## MANDATORY BULLETIN No. SPORTSTAR – 005 a

Visual inspection of attachment of the hand control slide bearing

brackets

## Appendix 1 Procedure to inspect attachment of the hand control slide bearing brackets

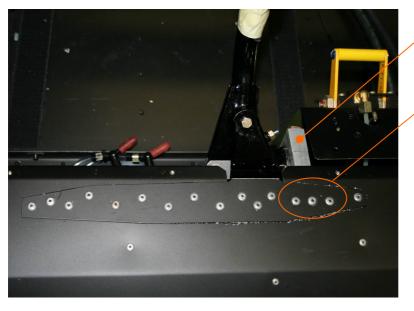
- 1. Uncover the seat upholstery (left and then right, also) and follow the pictures below to check, whether there are present 3 rivets opposite to the duralumin slide bearings (see lower picture), which attach slide bearing bracket upper flange to the upper flange of the wing-center section main spar. The rivets are hidden under a velcro strap, therefore touch the velcro to check their presence. If in doubt, tear off the end of velcro strap and glue it back after the inspection.

- 2. If the 3 highlighted rivets are riveted then the inspection is completed.
- 3. Record fulfilment with the bulletin into the Airplane Log Book.
- 4. If the 3 highlighted rivets are missing on any of sides, then contact the airplane producer immediately through your local dealer for further instructions. A more thorough inspection of the hand control attachment will be necessary with adding of missing rivets.

**3 rivets** attaching upper flange of the left slide bearing bracket to the upper flange of the wingcenter section main spar.

Inspect attachment under right seat, as well!
